SERVICE BULLETIN

AMATEUR RADIO

| SUBJECT | DATE |
|-----------------------------------|--------|
| TS-940S AVR UNIT CAPACITOR CHANGE | 4-8-86 |

AVR UNIT (X43-1500-00) Component side view

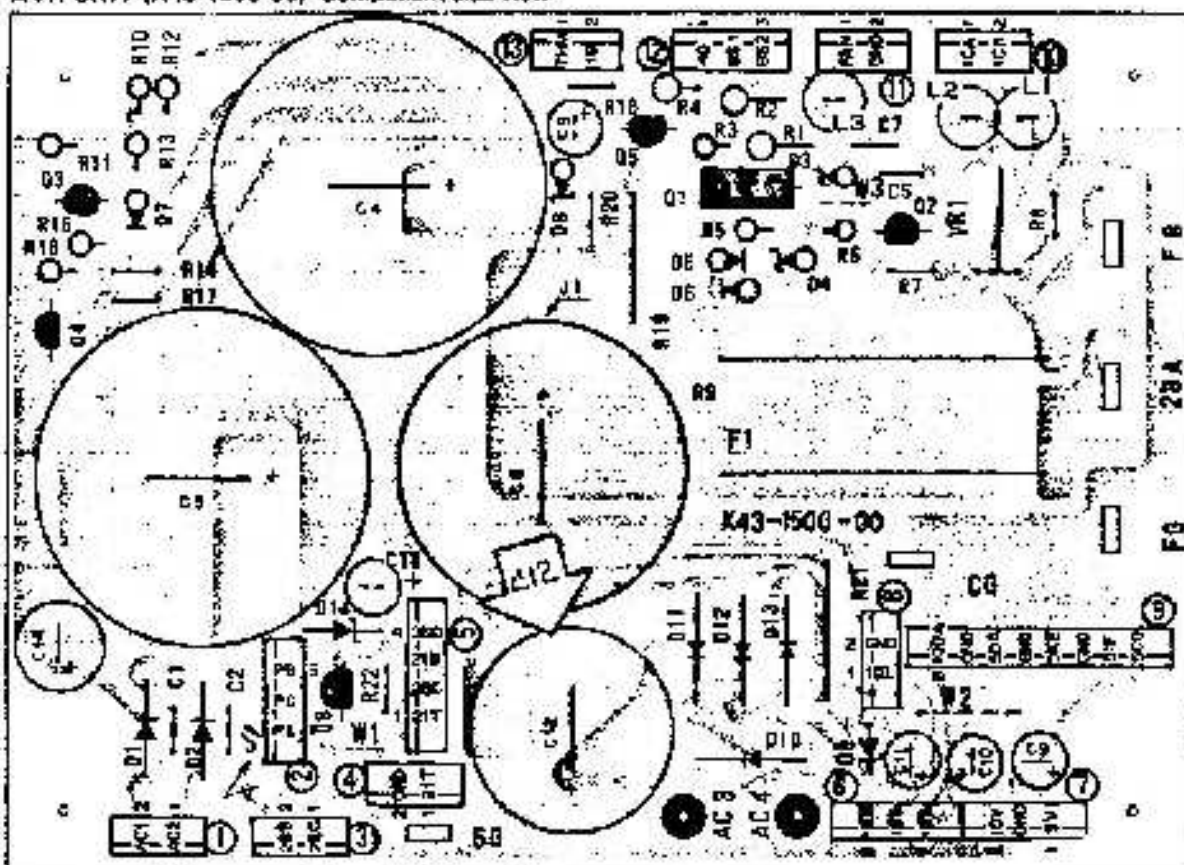
In those areas of the country that are subject to large power line voltage fluctuations, excessive voltage may be applied to capacitor C12 on the AVR Unit (X43-1500-00). These voltage fluctuations might exceed the capacitor breakdown voltage. Replacing capacitor C12 with a capacitor having a higher breakdown voltage will help prevent this potential problem.

On the AVR Unit (X43-1500-00) change C12 from a 6800 μ F capacitor to a 5600 μ F 25 v capacitor (C98-2837-05).

RF UNIT

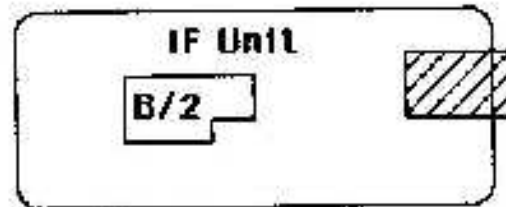
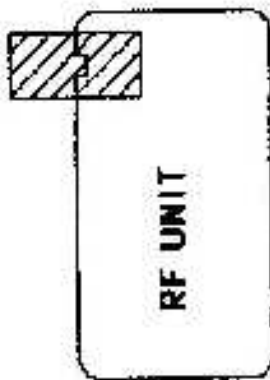
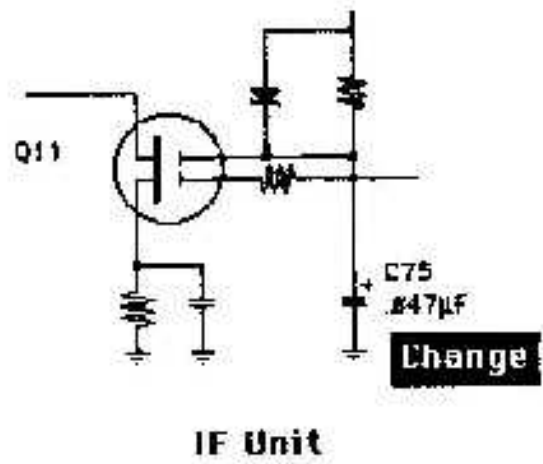
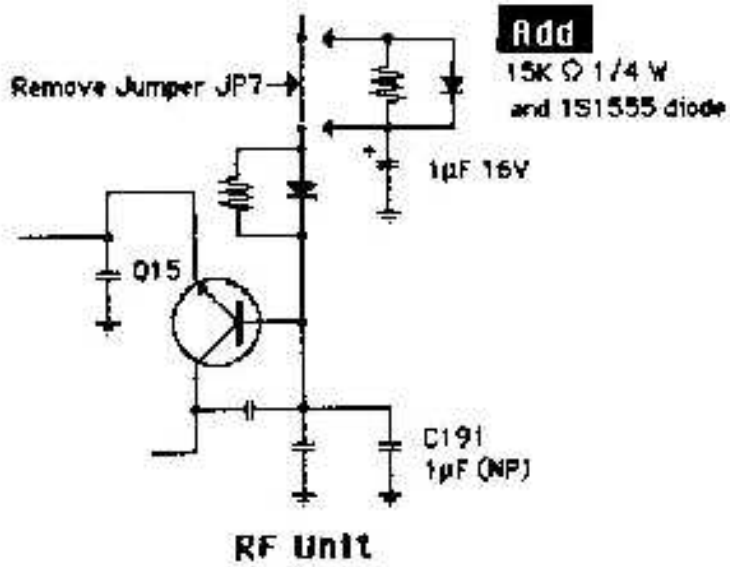
The following changes will improve the adjacent channel rejection of the TS-940S when a relatively strong nearby signal is present (S-4 or above).

1. Remove jumper wire JP7 and replace it with the parallel combination of the 15 k ohm resistor and the 1S1555 diode. Pay close attention to polarity.
2. Add the 1 uF capacitor as shown in the diagram.

Change capacitor C75 from a 1 uF 50 v capacitor to a .047 uF 50v capacitor.

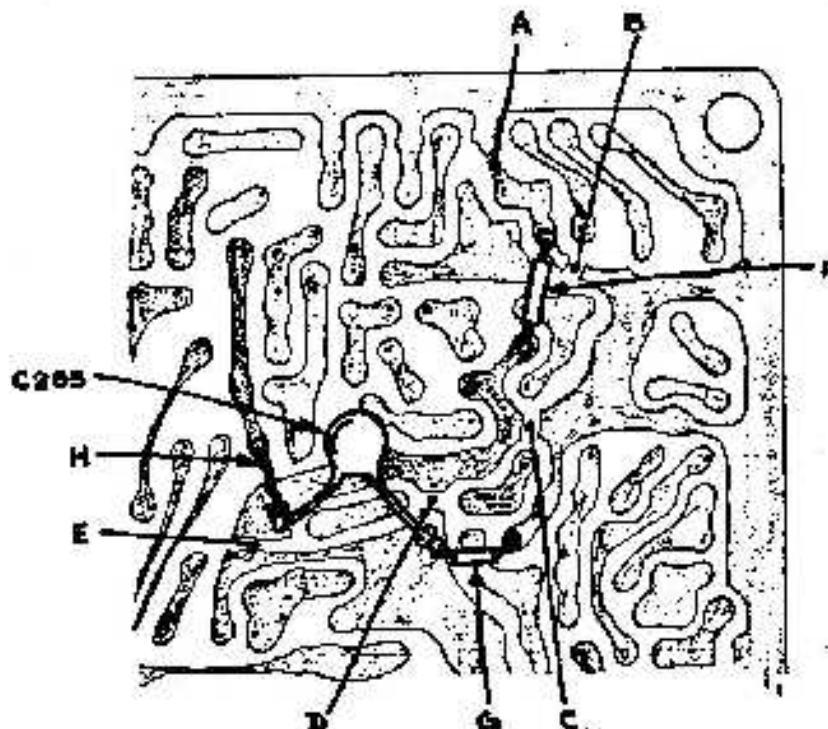
For reports of a low level audio hum superimposed on the normal transmitted audio, especially when the Speech Processor is used perform the following modification.

- Cut the foil patterns labeled A-E in figure 1.
- Add the jumper wires labeled F-H in figure 1.
- Add capacitor C285 .01 uF 50 v as shown.

IF UNIT (X48-1430-00)

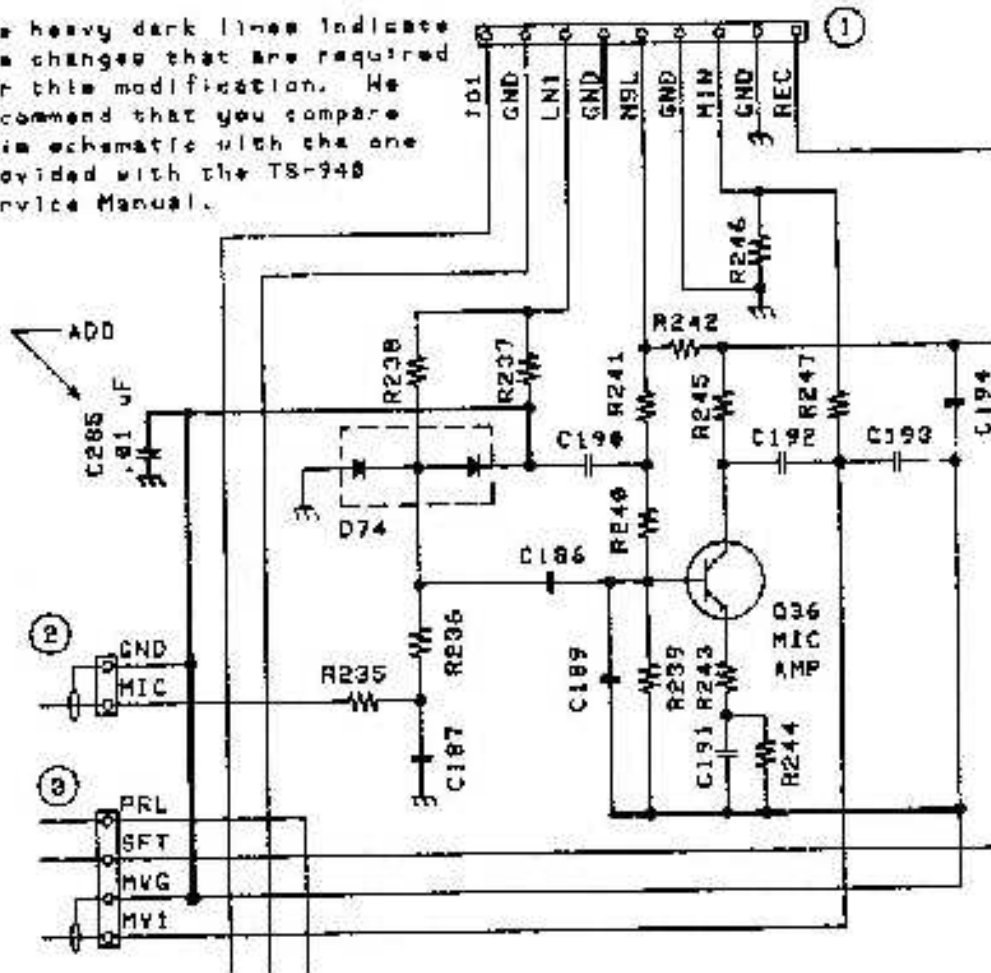
The heavy dark lines indicate the changes that are required for this modification. We recommend that you compare this schematic with the one provided with the TS-940 Service Manual.

IF UNIT (X48-1430-00)

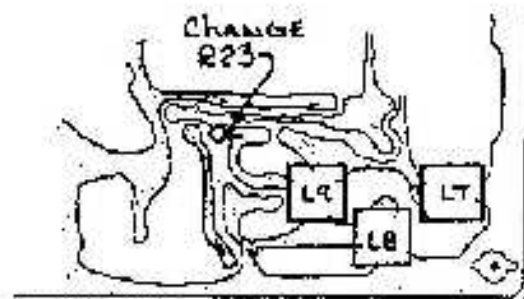
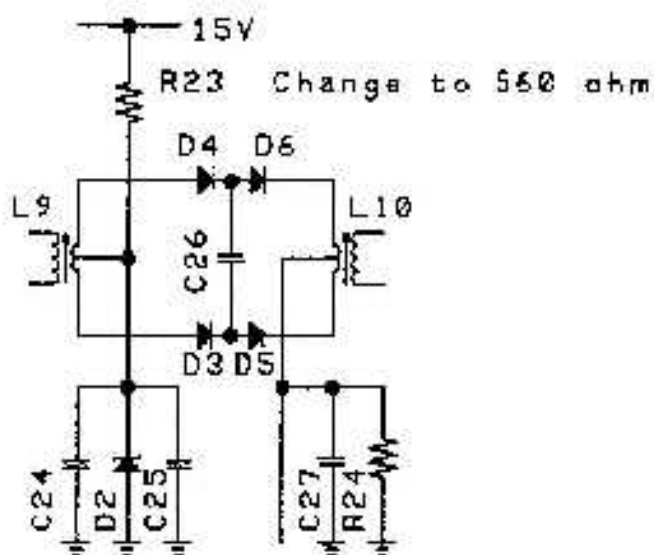
The following change will reduce the tendency of the Zener Diode in the Noise Blanker circuit to cause an increase in the ambient noise level. This change ensures that no current flows thru this diode in the normal receive position.

On the IF UNIT (X48-1430-00) change R23 from 330 ohms to 560 ohms.

PLL Unit (X50-2020-00)

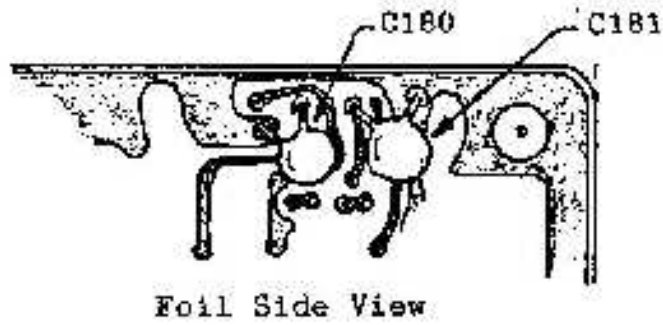
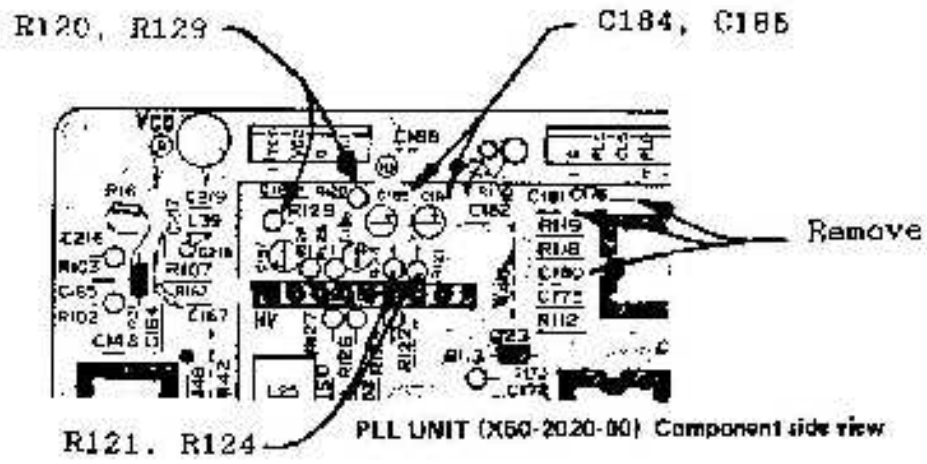
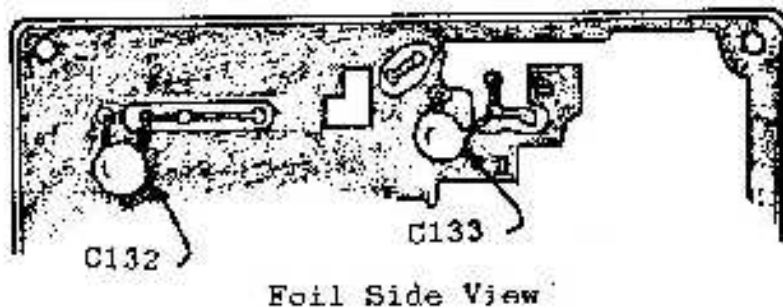
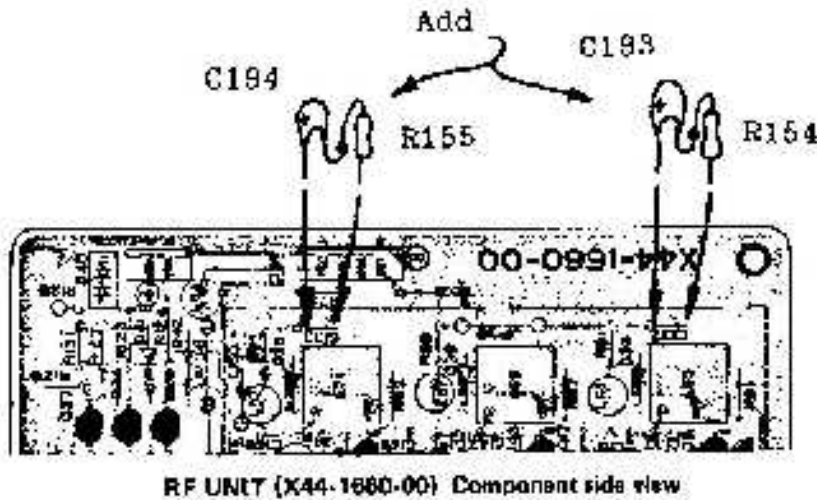
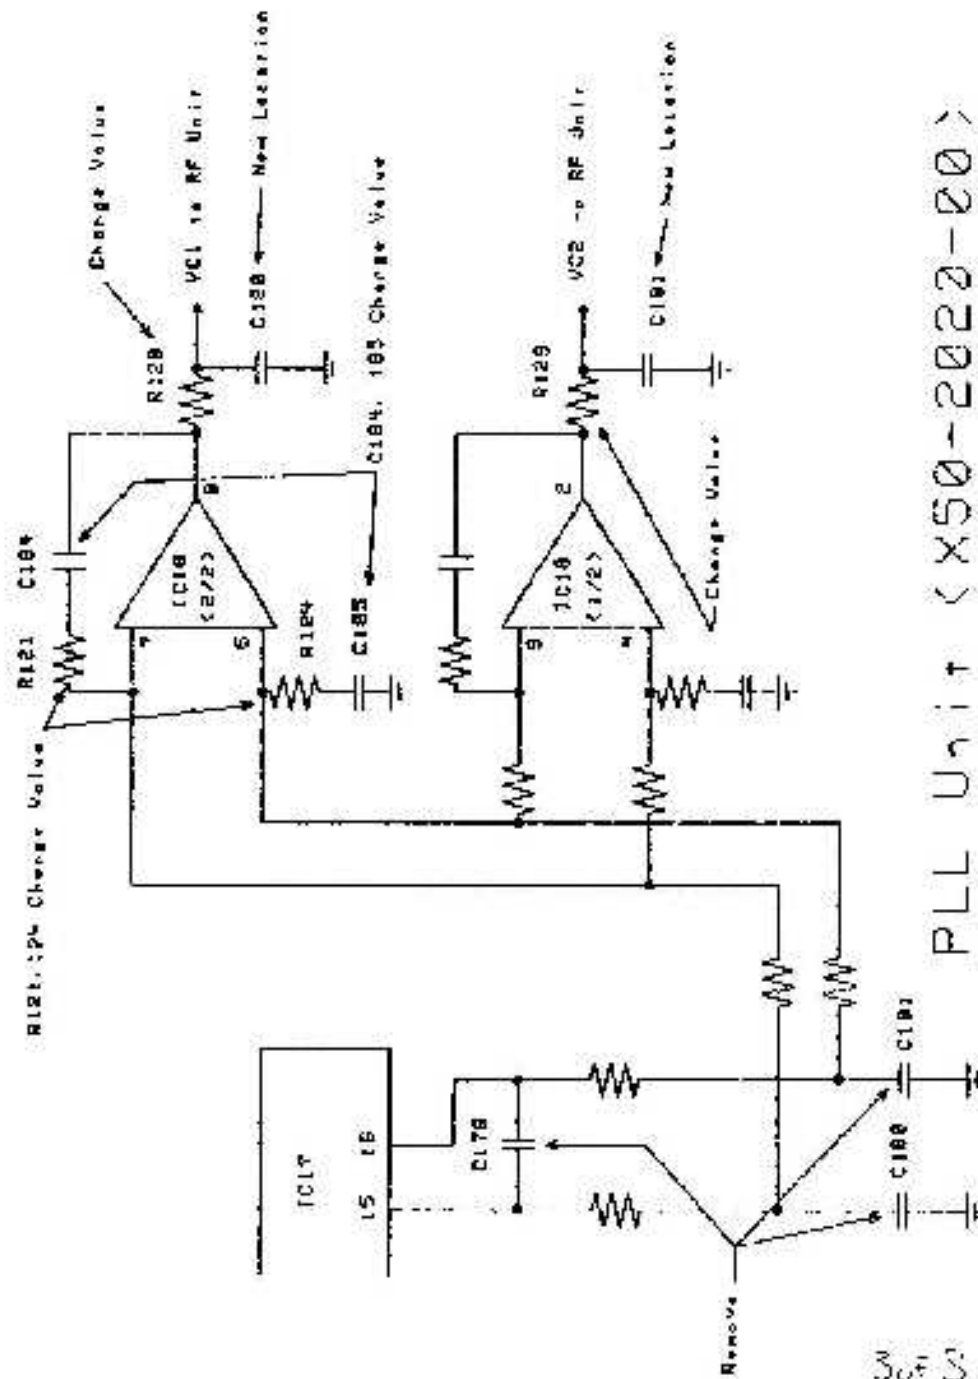
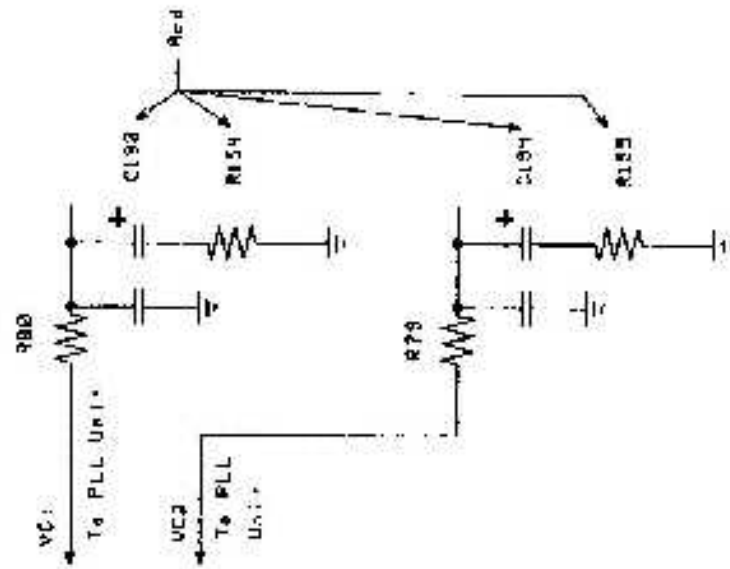
The Carrier to Noise ratio of the TS-940S may be improved by the following changes. This bulletin supersedes bulletin number 911 dated September 15, 1986.

On the PLL UNIT (X50-2020-00) remove capacitors C176, C180, and C181. Change resistors R120 and R129 from 470 ohms to 3.3 K ohms. Change resistors R121 and R124 from 1 K ohm to 680 ohms. Change capacitors C184 and C185 from .22 uF to .33 uF 35V tantalum capacitors. Install C180 and C181 in the positions shown in the accompanying diagrams. The use of new capacitors is recommended to improve reliability, don't try to reuse the old capacitors! Capacitors C181 and C180 should be attached to the foil side of the PLL unit.

On the RF Unit (X44-1660-00) install the series RC circuits composed of R154 and C193, and R155 and C194, as shown in the accompanying diagrams. As the diagrams illustrate it is easiest to move C192 and C193 to the foil side of the board and install the series RC circuits on the component side.

FIGURE 1

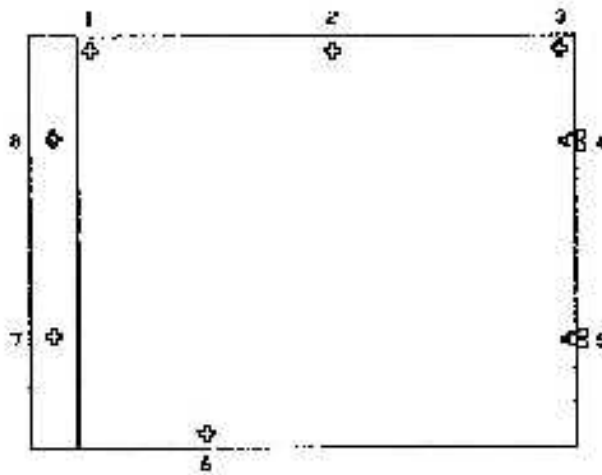
TS-940S in the serial number range of 601xxxx through 708xxxx may be limited in SSB peak power as compared to full CW output. The level may be increased by changing the value of capacitors C182 and C183 in the ALC circuit on the Control board. The recommended replacement value for each capacitor is 0.0022 uF, 50V (PART # CK45B1H222K).

4. Locate transistor Q37 on the board (toward the back right hand side). The two capacitors are mounted on the foil side of the board underneath Q37.
5. To access the bottom of the board remove the 8 screws that mount the board and heat sink to the chassis (See figure 1).

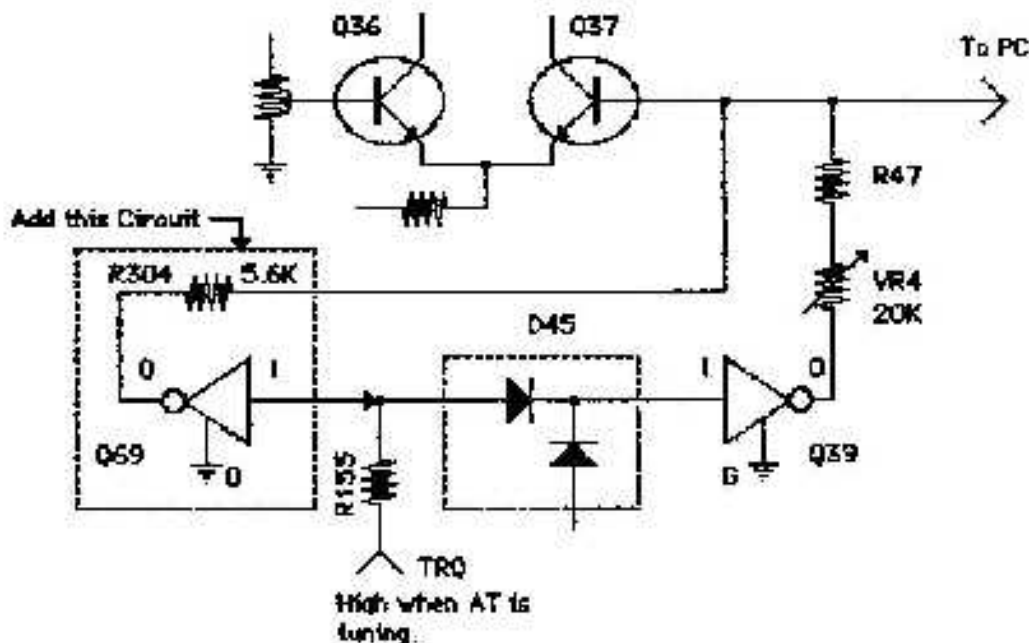
Occasionally during operation of the AT-940 a VSWR of greater than 1.5 to 1 might cause overloading of the relay contacts in the antenna tuner. This may be especially noticeable when switching BANDS, or if TUNING is performed too frequently. The following procedure should reduce or eliminate this tendency.

1. Add the circuit as shown below.
2. After the circuit has been installed adjust VR4 for a 10-15 watt output when the antenna tuner operates.

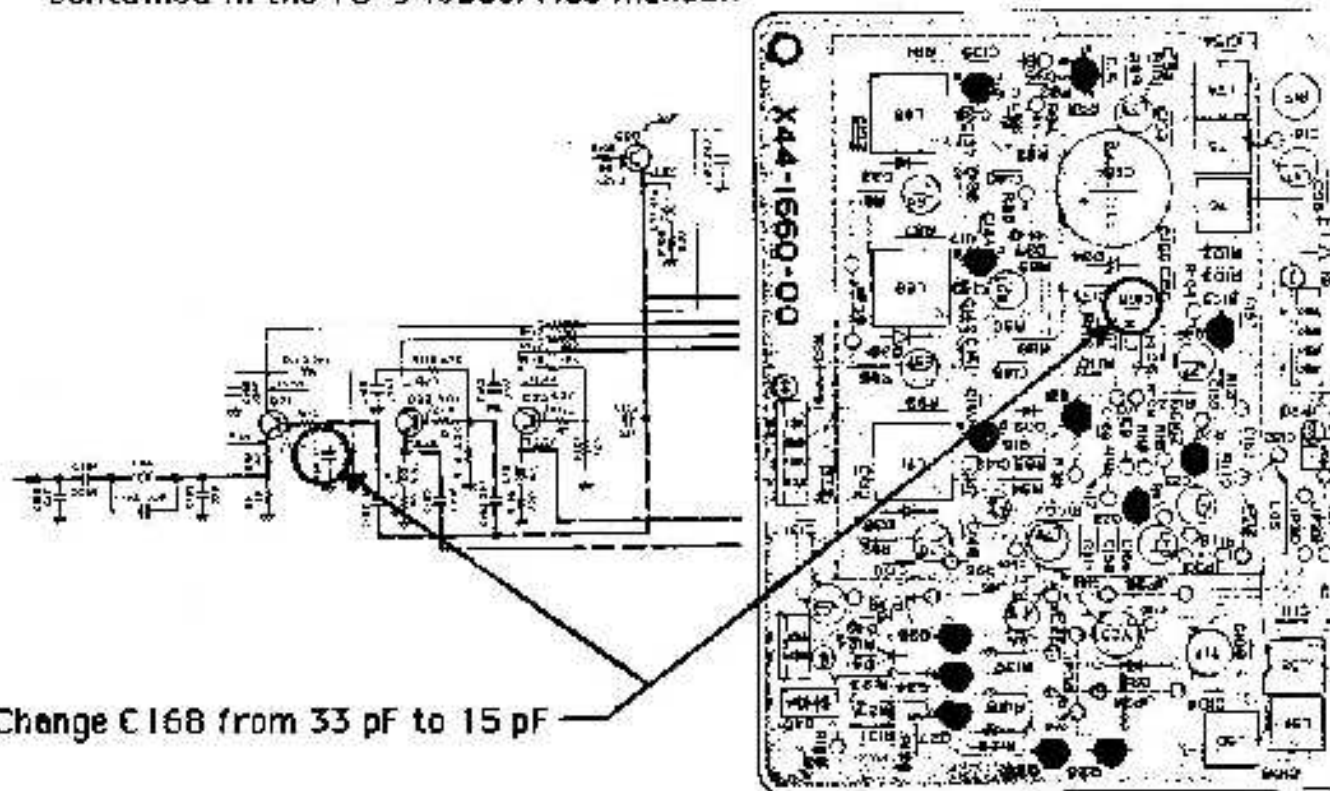
Reports of a PLL Unlock on the lower frequencies may be due to low VCO levels. The following change will increase the VCO level and should prevent recurrence of this symptom.

1. On the RF Unit (X44-1660-00) change C168 from a 33 pF capacitor to a 15 pF 50 v capacitor.
2. Readjust the VCO BPF (RF unit L74-76) according to the instructions contained in the TS-940S service manual.
